Staff Report

August 17, 2026 Council Workshop Meeting

Change Order #1 Well 6-14 Water Transmission Main

Figure 1: Well 6-14 Water Transmission Line

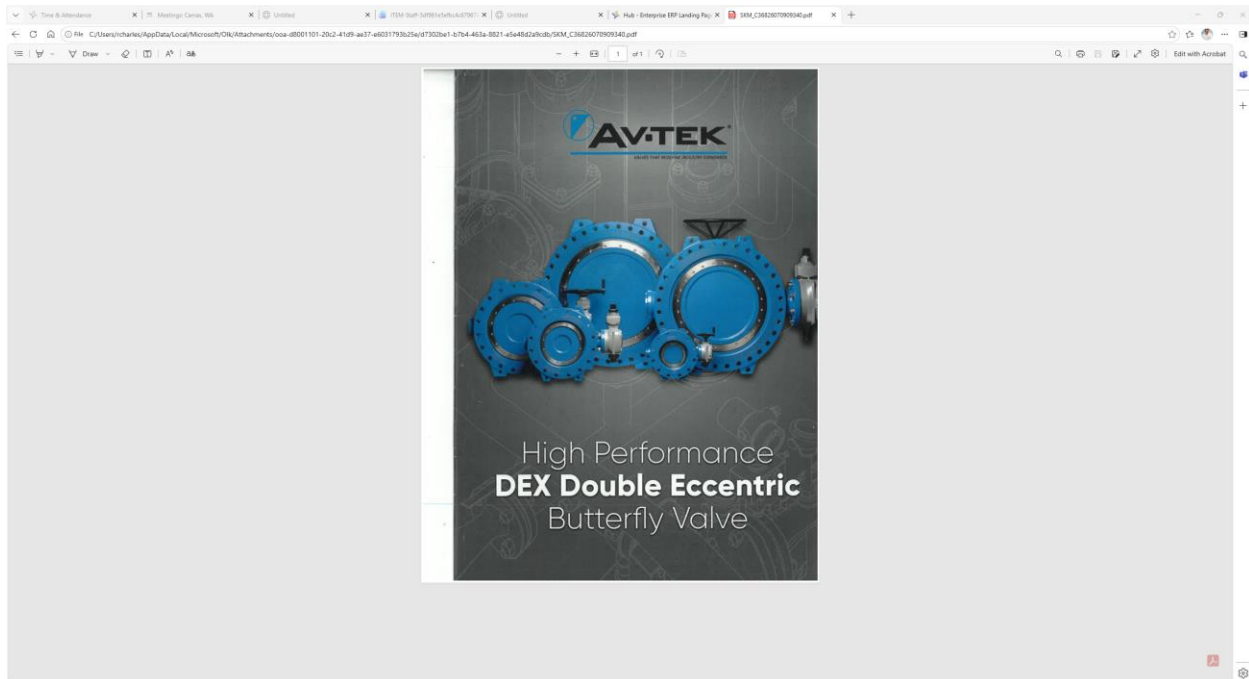
During the preparation of final plans, it was determined that the 18" High Density Polyethylene (HDPE) pipe that was called out in the plans did not have sufficient pressure rating to meet the pressure produced by the wells pumping at the same time. A change to a higher pressure rated pipe was made, but the pipe size was kept the same.

Unfortunately, the higher pressure rated 18" pipe was thicker walled which reduced the inside diameter of the pipe to 13.30 inches which isn't sufficient to convey the volume of water from both wells. The error was not found until the contractor submitted specifications for the HDPE pipe. To correct the problem, the pipe material was changed to ductile iron pipe since HDPE pipe needed to convey the water would have to be 24" in size and is only made to order pipe in this size. The Change Order reflects the cost of using ductile iron pipe for the entire project with a credit for the HDPE pipe.
